WYNNFIELD SUBDIVISION UNIT FIVE

Revised for the April 7th meeting:

APPLICATION NUMBER Holdover DATE April 7, 2005

DETAIL SITE PLAN

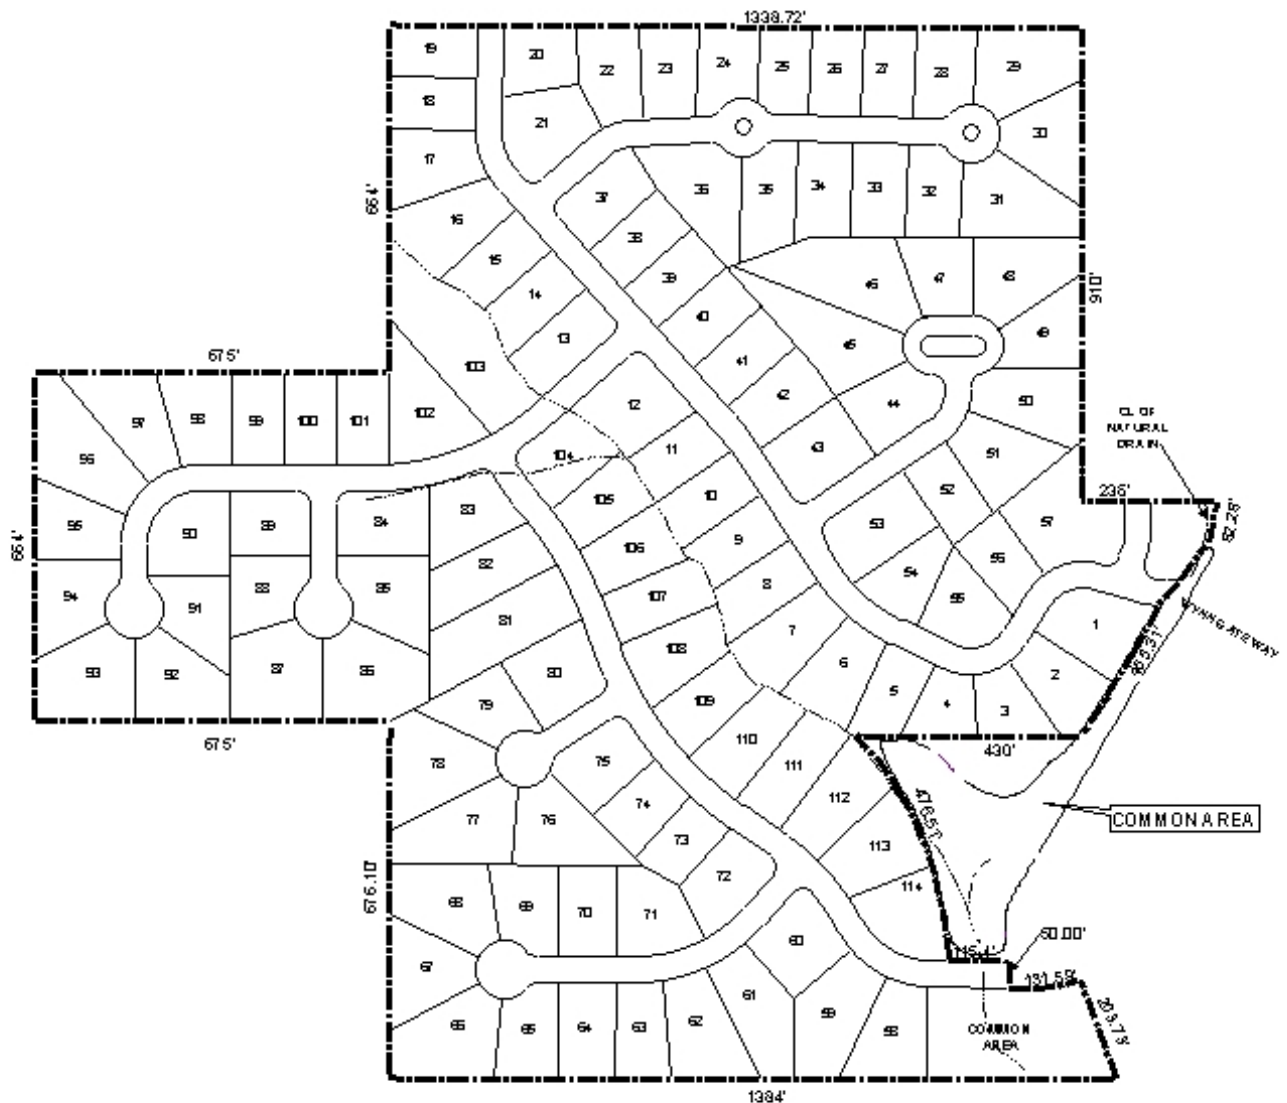
During the March 17th Planning Commission meeting, the applicant was also directed to provided a right-of-way stub, or 25-foot wide frontage onto a dedicated street, for a land-locked parcel to the east of proposed lots 29-31, and 48-49; the applicant has indicated a new right-of-way stub north of proposed lot 1, but this new stub serves a lot associated with the Isle of Palms

subdivision, which already has access to a street; and not the land-locked parcel in question. The applicant should again revise the plat to provide at minimum a 25-foot wide frontage onto a dedicated street in the vicinity of proposed lots 29-31, or 48-49, and remove the unnecessary stub that has been provided north of proposed lot 1.

The revised plat creates another land-locked parcel condition to the west of proposed lots 93-96. The applicant should revise the plat to provide at minimum a 25-foot wide frontage onto a dedicated street to serve parcel R023303073000003., located west of proposed lots 93-96.

The revised plat does not depict a right-of-way stub to the Raleigh subdivision to the south, which was one of the conditions listed in the December 1995 Letter of Decision for the original application. The Raleigh subdivision was also given this condition in order to ensure connection between the two subdivisions. Therefore, the applicant should revise the Wynnfield plat to provide a right-of-way stub to the south.

1) provision of a minimum 25-foot wide frontage onto a dedicated street for the land-locked parcel (R023303071000023.), to the east of proposed lots 29-31 and 48-49; 2) provision of a minimum 25-foot wide frontage onto a dedicated street for the land-locked parcel (R023303073000003.), to the west of proposed lots 93-96; 3) provision of right-of-way stub to the Raleigh subdivision to the south, per the requirements of the December 1995 Letter of Decision for the original Wynnfield application; 4) removal of the street-stub provided north of proposed lot 1; 5) placement of a note on the final plat stating that maintenance of all common areas and detention areas shall be the responsibility of the property owners; 6) that all roads be constructed to City of Mobile standards; 7) depiction on the final plat of the 25-foot minimum building setback line; 8) placement of a note on the final plat stating that any lots which are developed commercially and adjoin residentially developed property must provide a buffer in compliance with Section V.A.7. of the Subdivision Regulations; and 9) compliance with all applicable federal, state and local regulations regarding the potential wetlands issues.
